RE: City of Decatur WWTP Inspection
AFIN: 04-00052 Permit No.: AR0022292

OFFICE OF WATER QUALITY INSPECTION REPORT

RE: Decatur AR WWTP Inspection Response. AFIN: 04-00052, Permit No: AR0022292.

Existing Sludge Press, or temp. Only Pressed Sludge is
slightly out of contained area. Last day we will use this
is 8/28/2018,

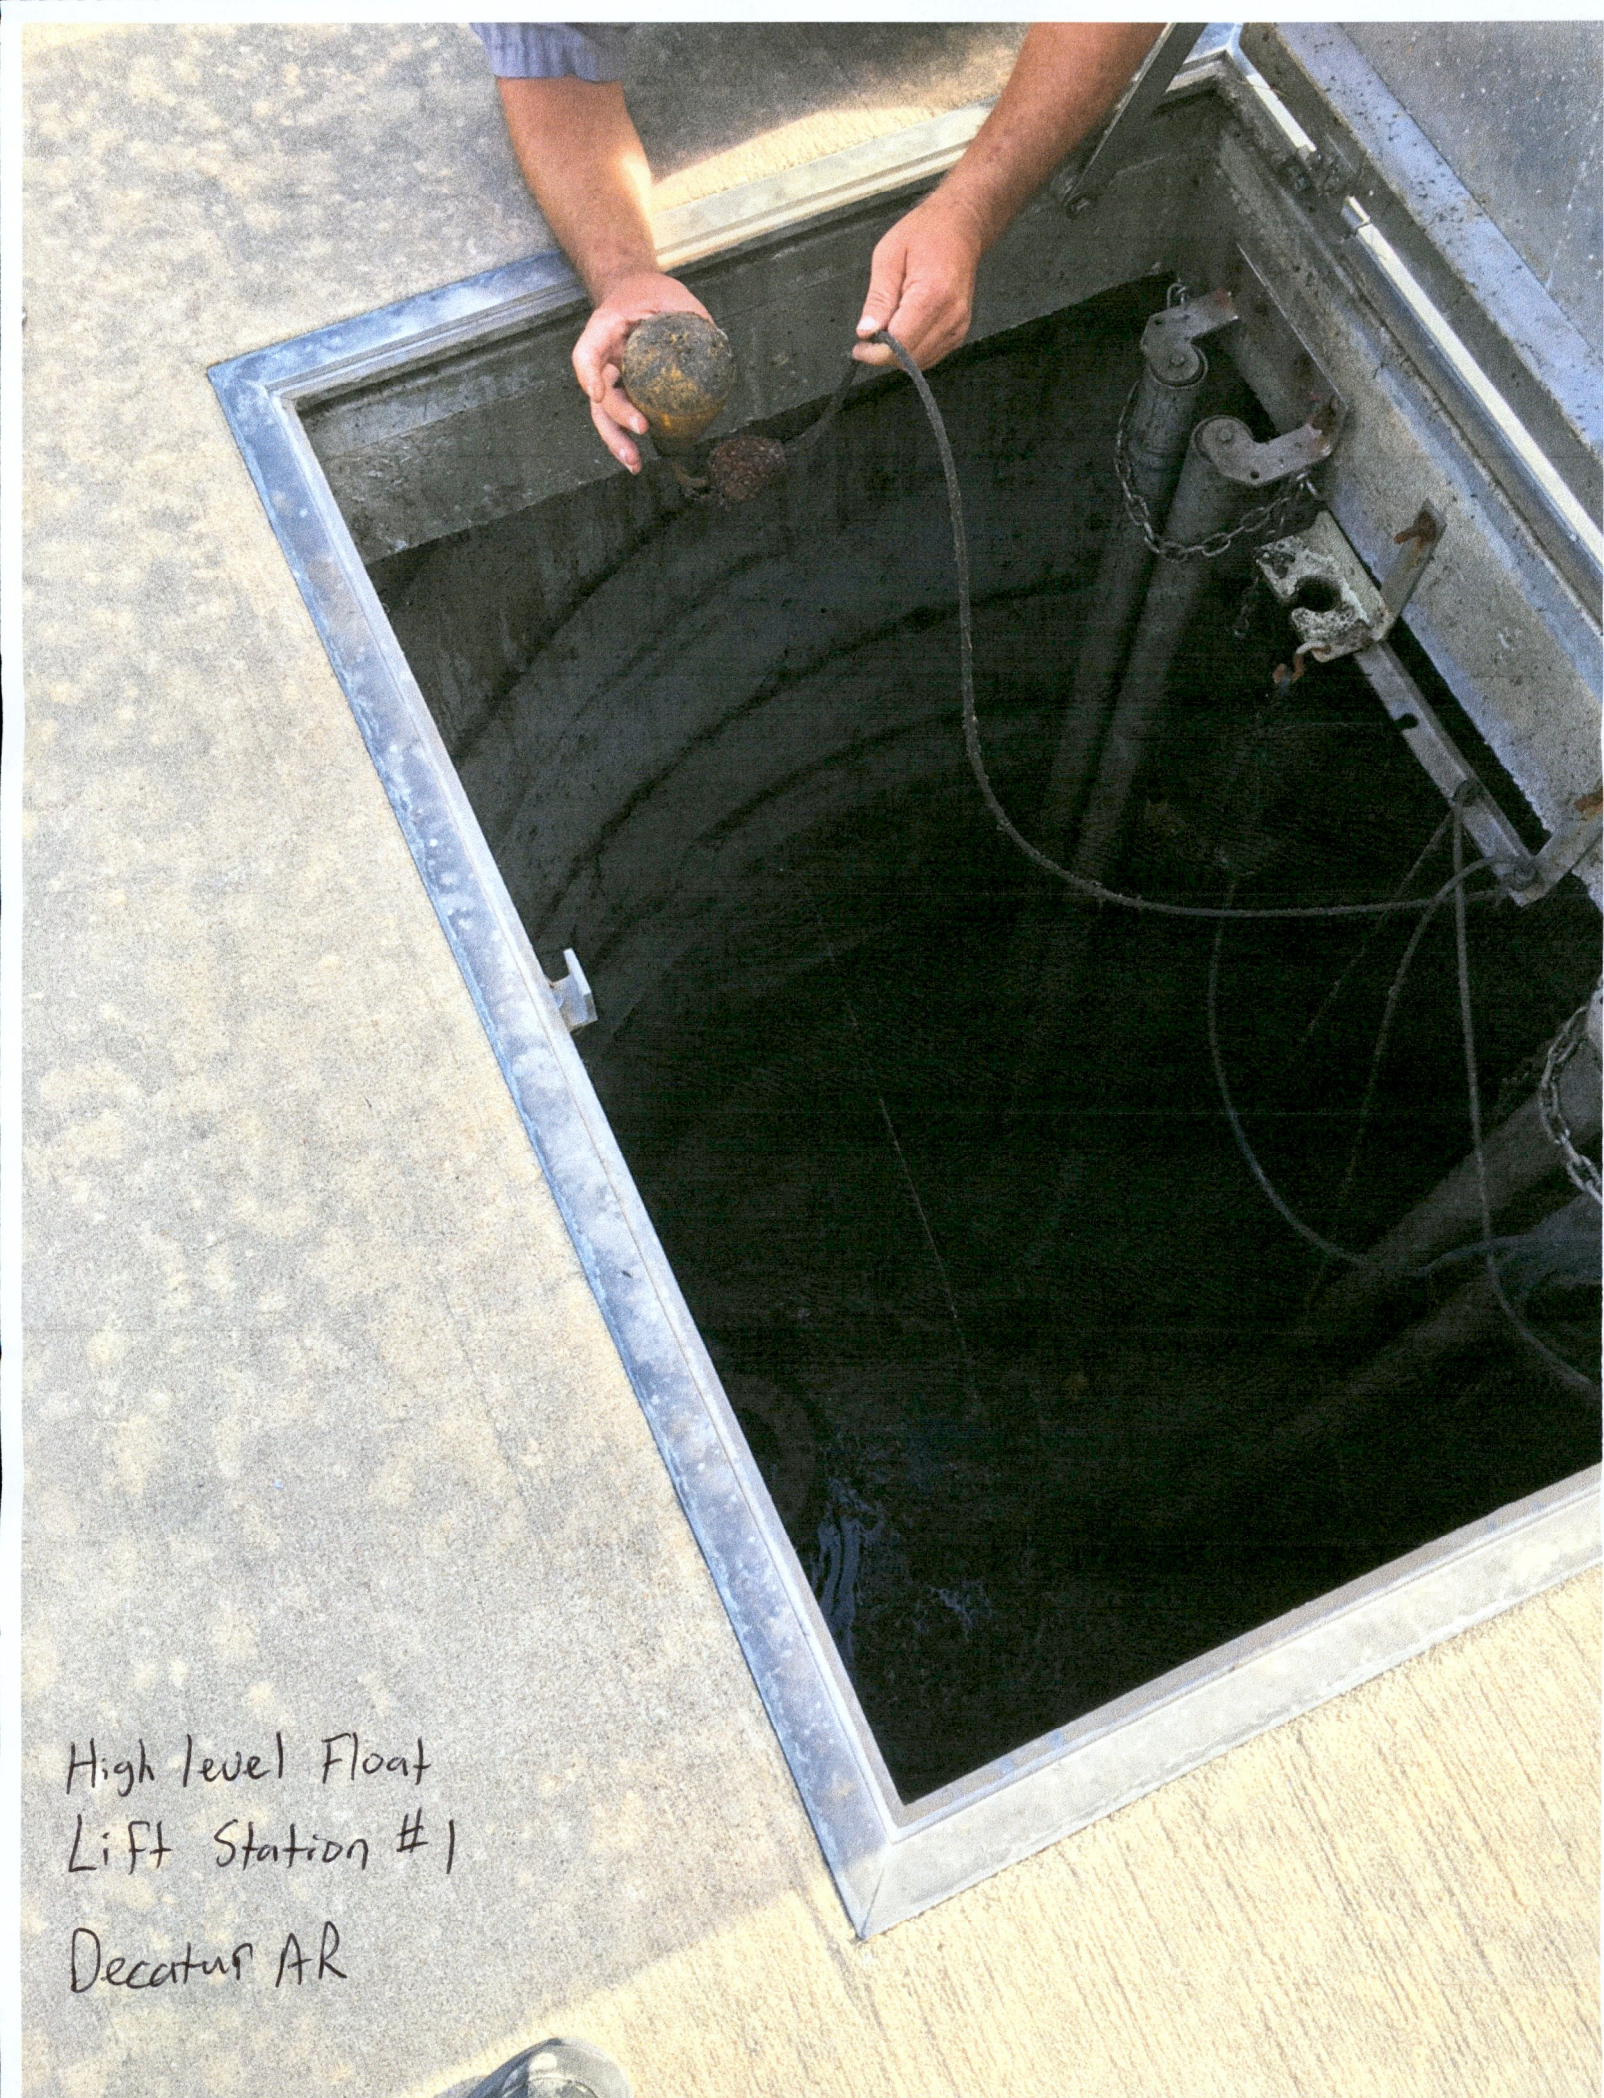
press is unable to be moved fully over the sludge drying beds. Your response also states that the sludge press will not be used during rain events and that dewatered sludge in the parking area will be removed daily. However, since the end of the press, conveyer system, and sludge transport truck are over the parking area and exposed to stormwater; and since dewatered sludge will still continue to fall onto the parking area, the No-Exposure Certification is no longer applicable to the facility. Please contact Jessica Temple, P.E., ADEQ Office of Water Quality Permitting Branch, at 501-682-0621 to discuss full coverage requirements under the Industrial General Stormwater Permit.

2. The dumpster at the headworks was missing a plug. We have plugged the dumpster and if it leaks in the future we will request a new dumpster immediately. The dumpster is under a covered carport area to minimize exposure to rainfall. I do not have a photo of the dumpster but I can send one after this letter if you need one.
Part B of this question is simple, we have storage for sludge, we do not press on weekends or if it is raining. The last day of our temporary sludge press use is September 28th. The sludge press well be removed and our new sludge operation well start up the first week or so of October. The new sludge operation has complete containment. A roof is to be put over the sludge containment pad also.
